FIELD SERVICE BULLETIN

NUMBER: 624

PRODUCT Chameleon Vision

PURPOSE Inform Field Service of a potential field failure of the Vision shutter actuator

Figure 1

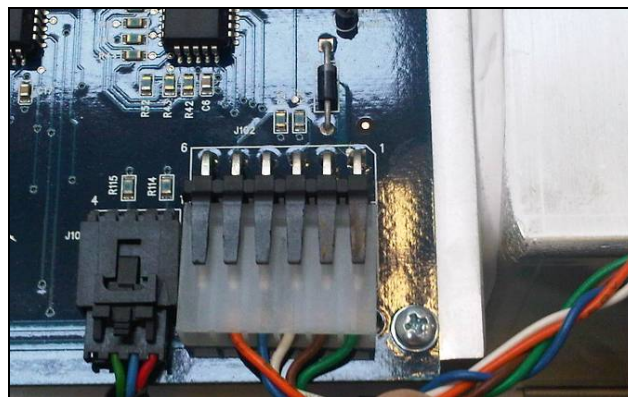
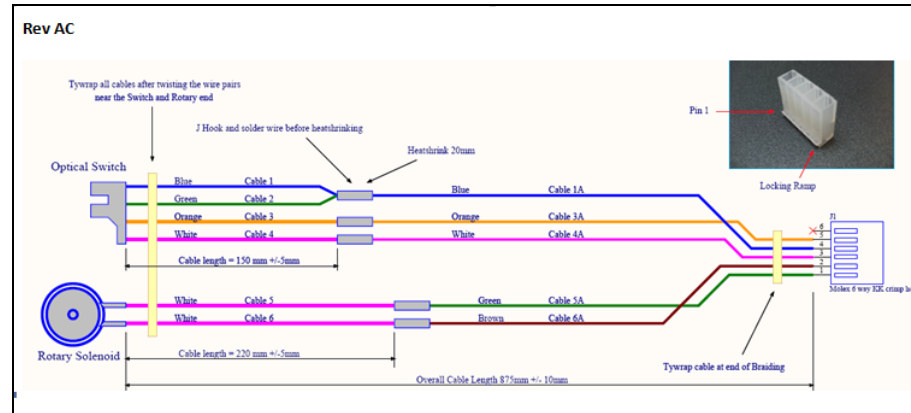
The supplier of the shutter actuator has wired some of the actuators incorrectly. The correct wiring is shown in Fig 1 and Fig 2 above. The J102 connector on the Verdi head board should be wired from pin 1 to pin 5 as Green, Brown, White, Blue, and Orange. We have checked all of our stock and discovered that some of the connectors have the Blue & Orange wires (pins 4 & 5) reversed.

The shutter initially works with this configuration sufficiently to get through the build phase, but after a short period of time the opto-coupler will fail.

ACTION REQUIRED For any Vision laser that is not yet installed, the outer lid should be removed before powering on and the J102 connector should be inspected for the correct wiring. Should you identify one that is wired incorrectly, it is safe to swap the wires over. If you identify one that has failed with the symptoms described above, a replacement shutter actuator is required. The replacement is a simple job but access to the underside of the laser is required.
